**WOKINGHAM
BOROUGH COUNCIL**

Outline Planning Approval Consultation

Application Number: 243099

Site Address: Land North Of Reading Road, Arborfield

Visibility Splays

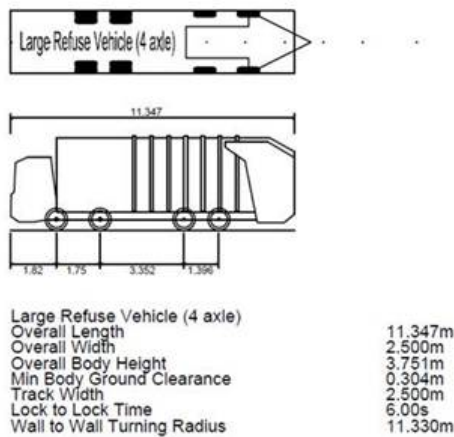
58. Visibility splays for the proposed new access have been submitted with reference to the 85th percentile speed of Reading Road. The calculations of the visibility splays would need to be submitted.
59. The visibility splay to the west appears that it maybe obstructed by the tree as shown below.

60. Evidence would need to be submitted that this is not the case.
61. Any landscaping within the splays would need to be maintained so that it is less than 0.6m high.
62. Pedestrian and cycling visibility splays need to be provided for the proposed access onto Reading Road.

Swept Paths

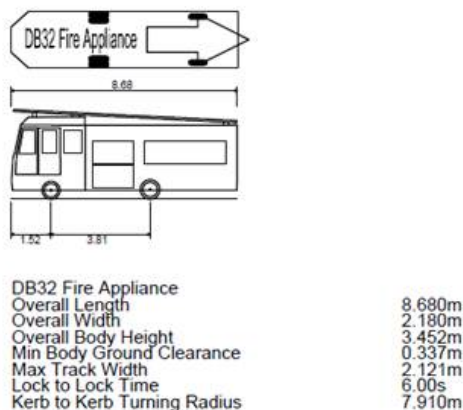
63. All movement swept paths of a refuse vehicle have been provided which is welcome. However, the dimensions are not acceptable. The dimensions that would need to be used are as follows: -

64. Highways would need to see swept paths of the refuse lorry entering the site from both directions whilst a car is waiting to exit.
65. Highways would need to see the swept paths for a refuse vehicle and a large car passing each other on the site roads.
66. Highways would also need to see the swept paths for the fire tender accessing and egressing the main access.
67. Please note that the dimensions of the fire tender approved by the Borough are as follows:
